# **Mt. Juliet, Tennessee**

## **Planning Commission**

### **Agenda**

**Thursday, February 20, 2025**

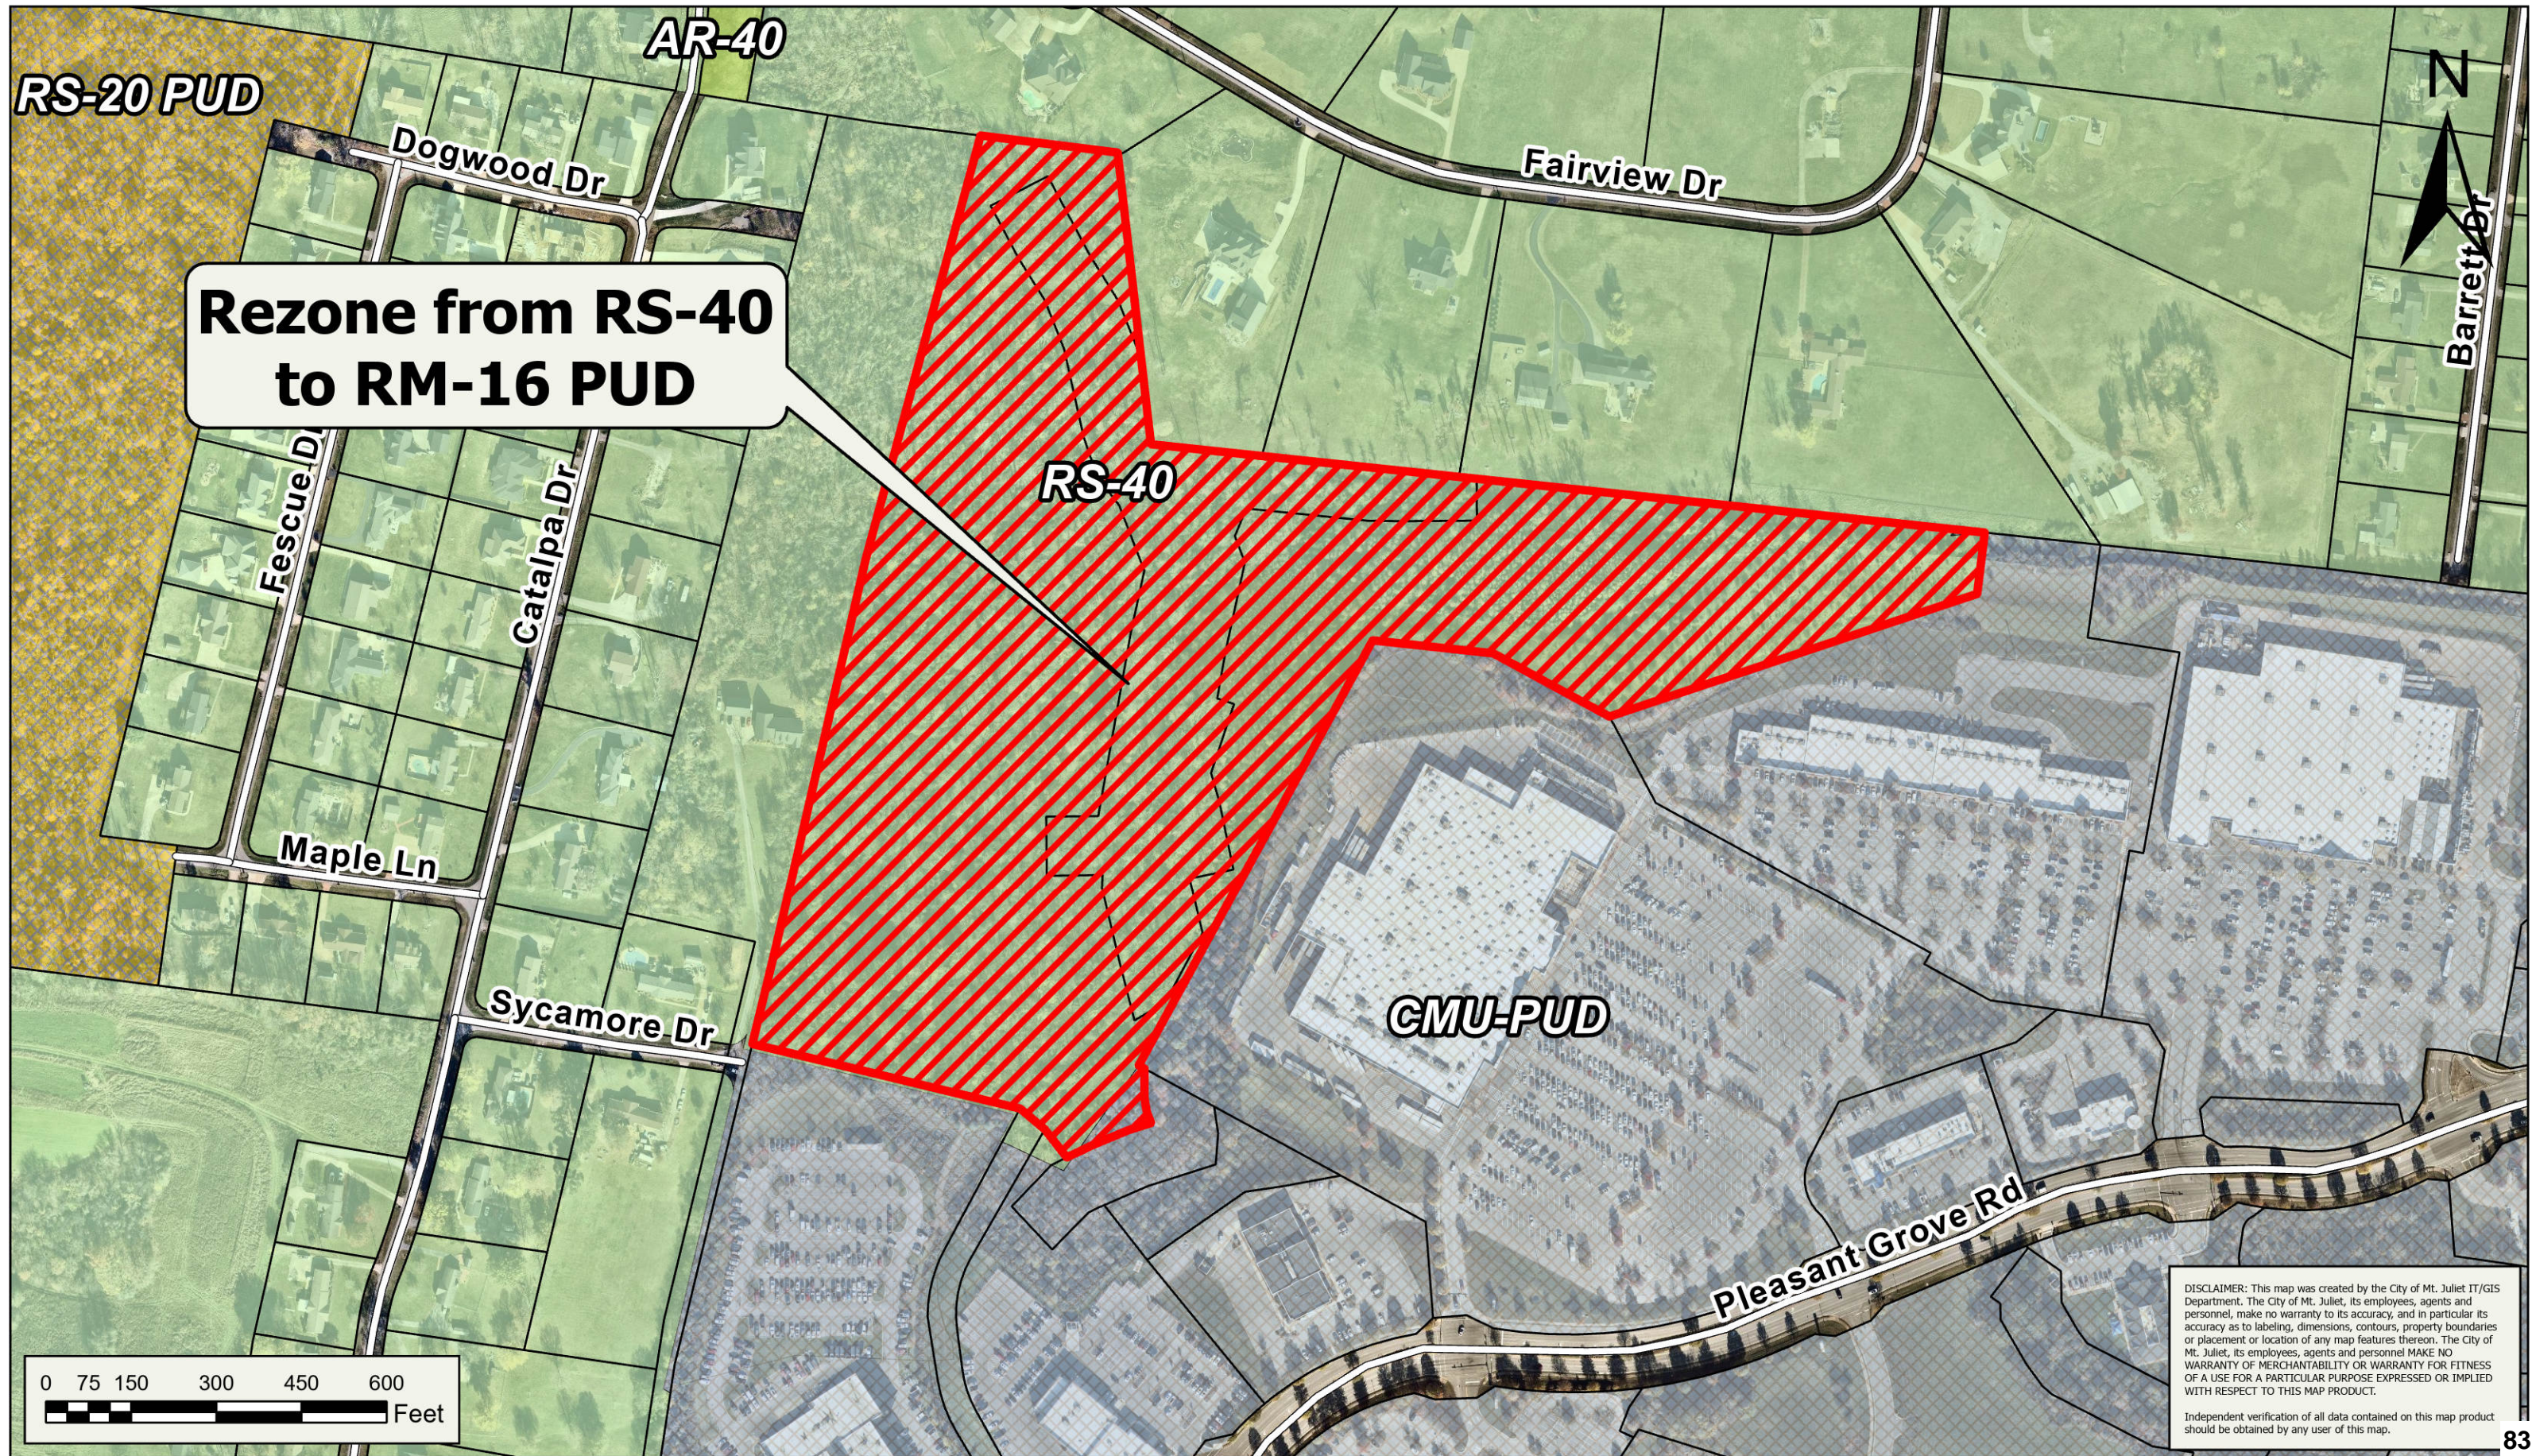
1. The water lines shown are not WWUD's design. There is a label that says 10' water line easement. The actual easement shall be 10' on each side of the centerline of the water line.

# Exhibit D - PMDP

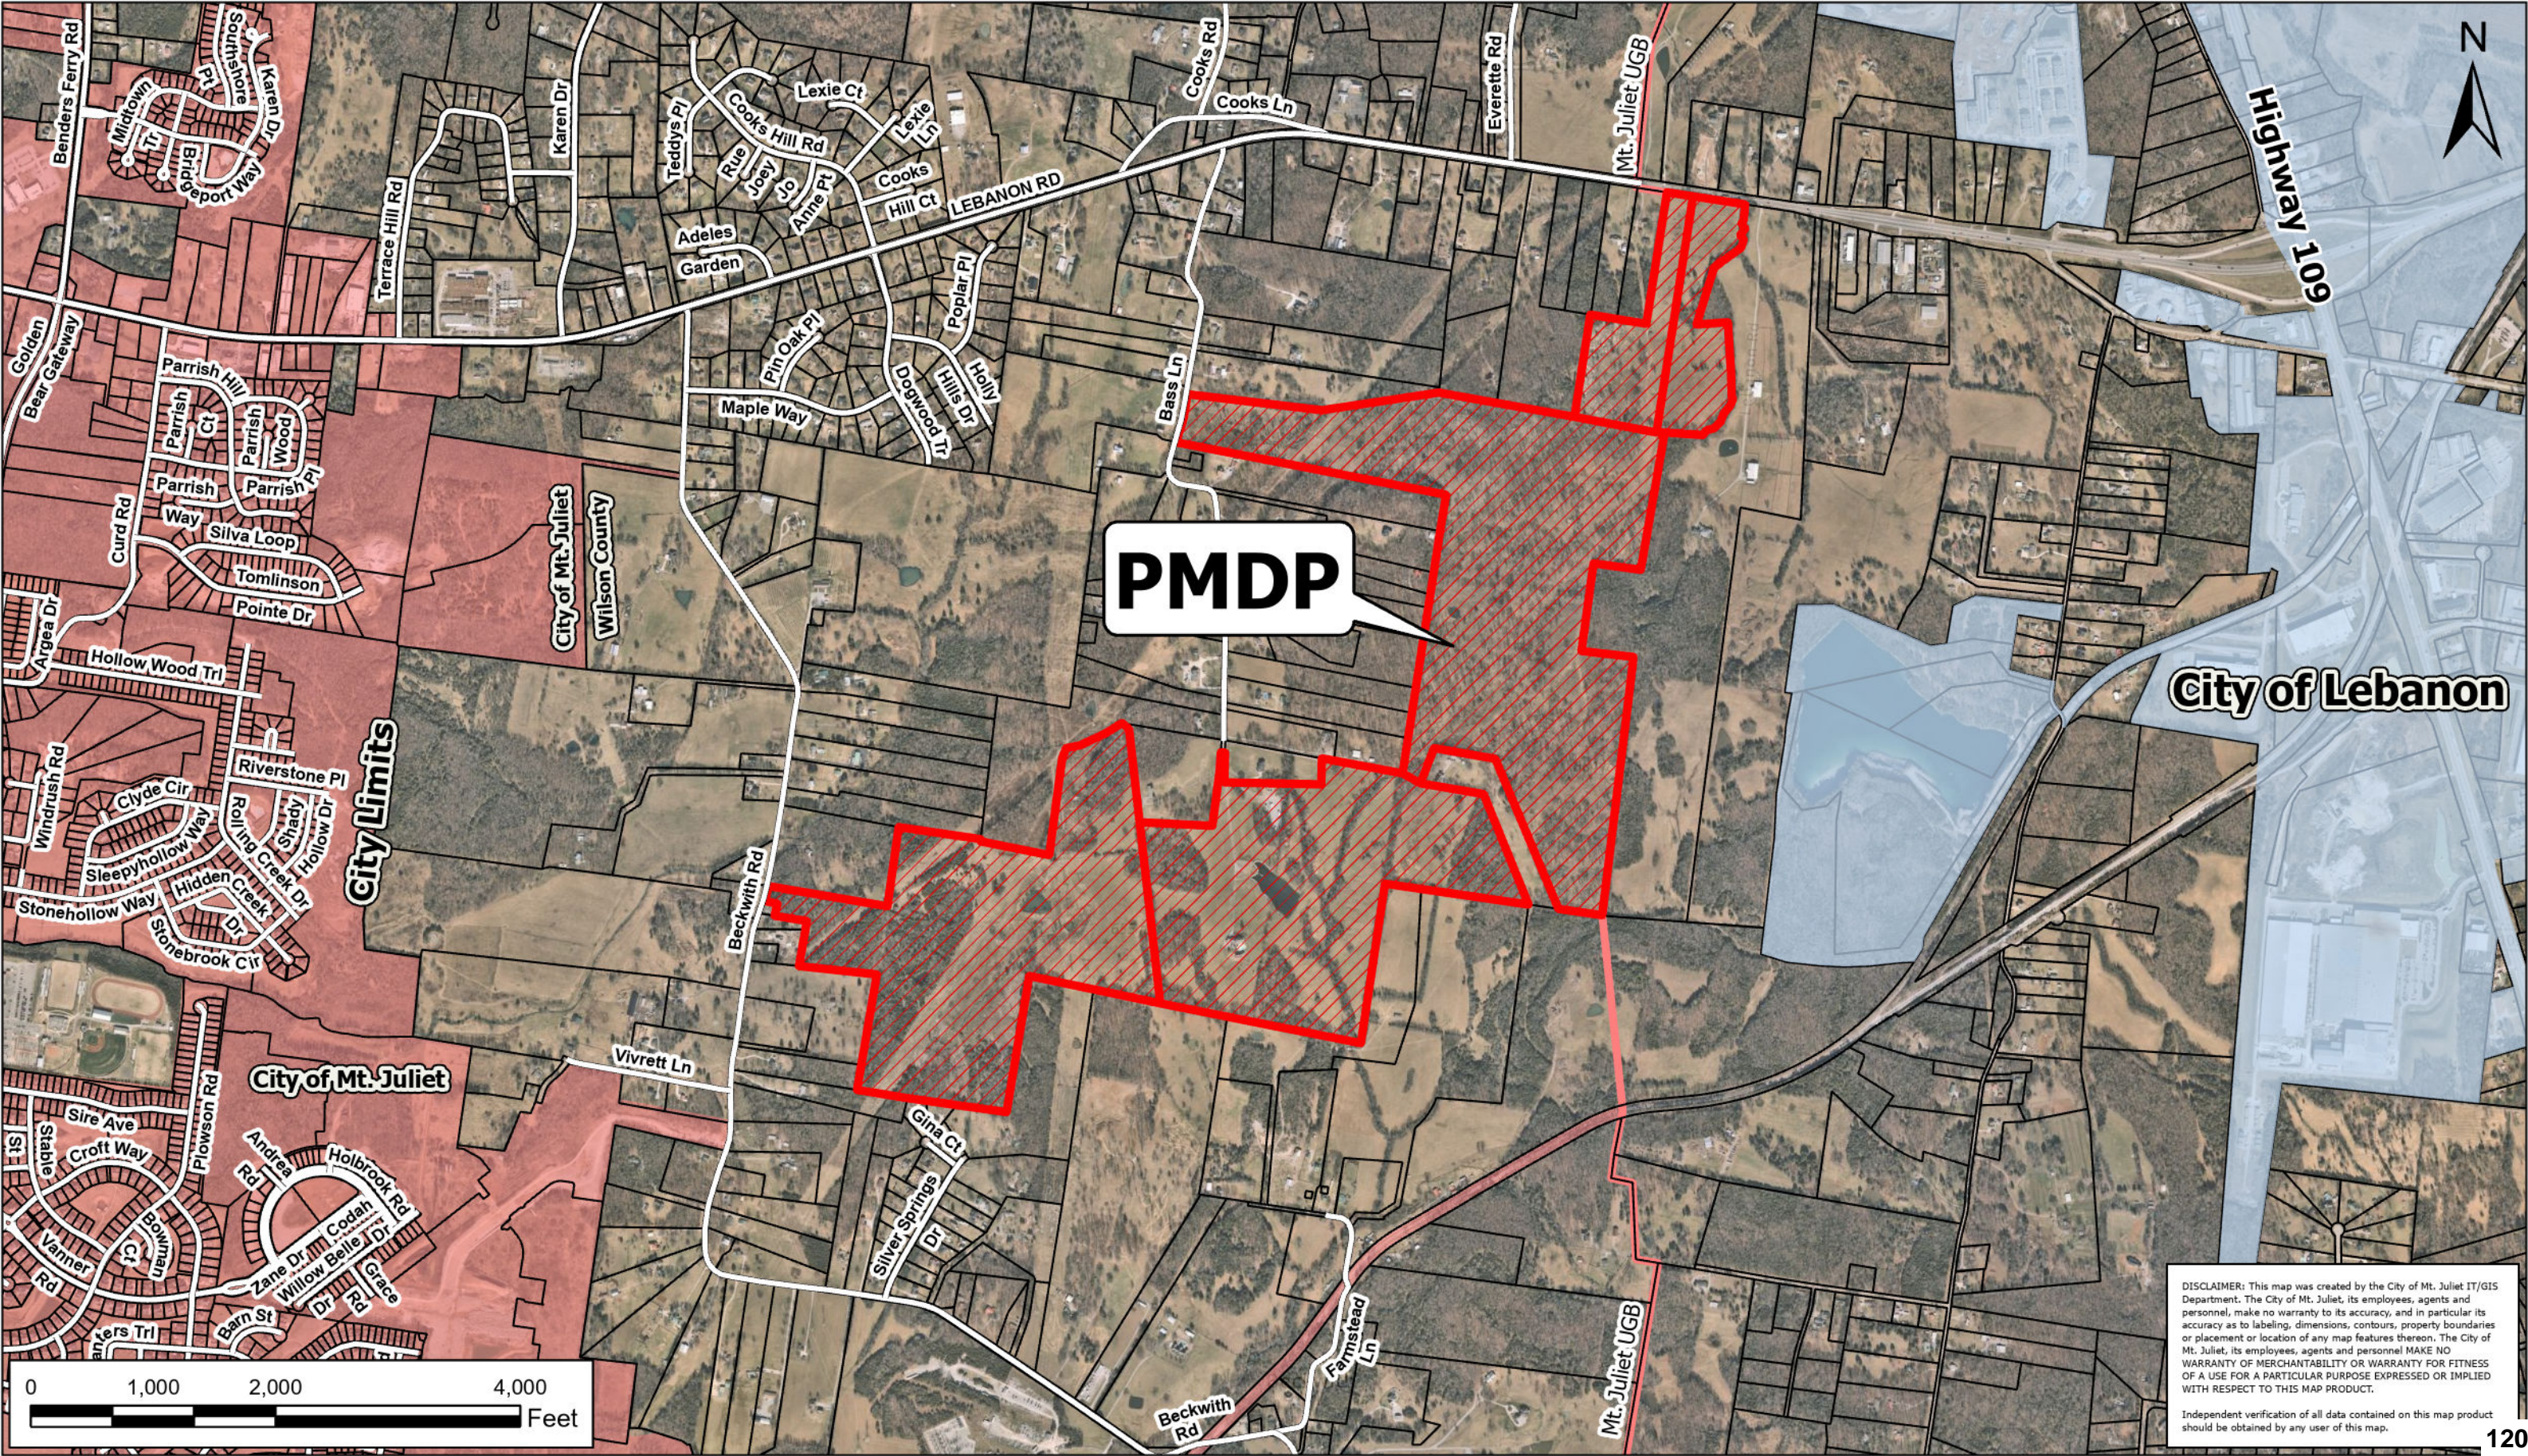
- f. Request to omit bicycle lanes on a residential collector (Standard Drawing ST-108): NOT SUPPORTED
  - g. Request to exceed maximum slopes on a collector up to 10% total (Sub. Reg. 104-4): SUPPORTED ONLY ON SECTIONS WITH NO FRONTAGE. Regardless of the variance, all collectors may not exceed 3% within 50 feet of intersections.

1. The proposed water lines shown are not WWUD's design.
